Urgent Field Safety Notice

SBN-CPS-2019-010

Version 3

cobas t 511/ t 711: Lifted cuvettes

Figure 1: Example of negative absorbance area

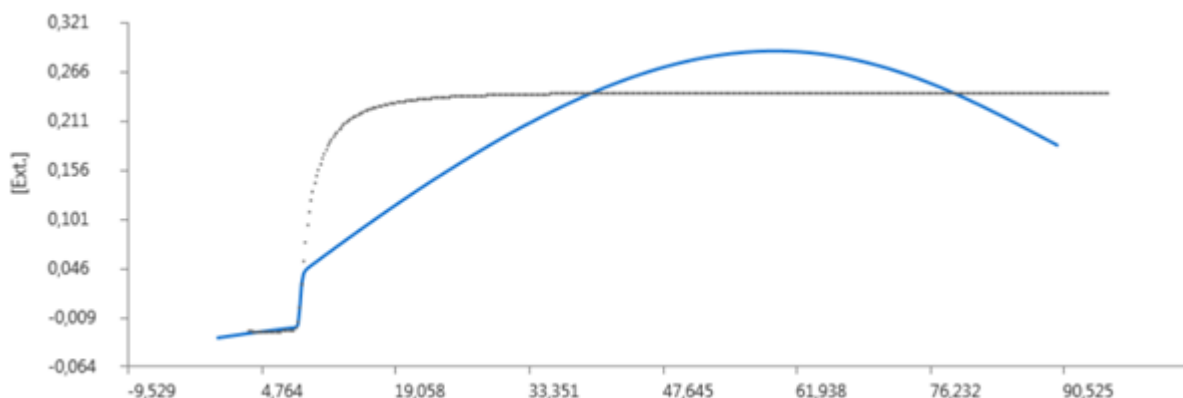
The clotting curve should be checked in order to determine if a cuvette was lifted.

This can be detected if the curve starts in the negative absorbance area (see example below).
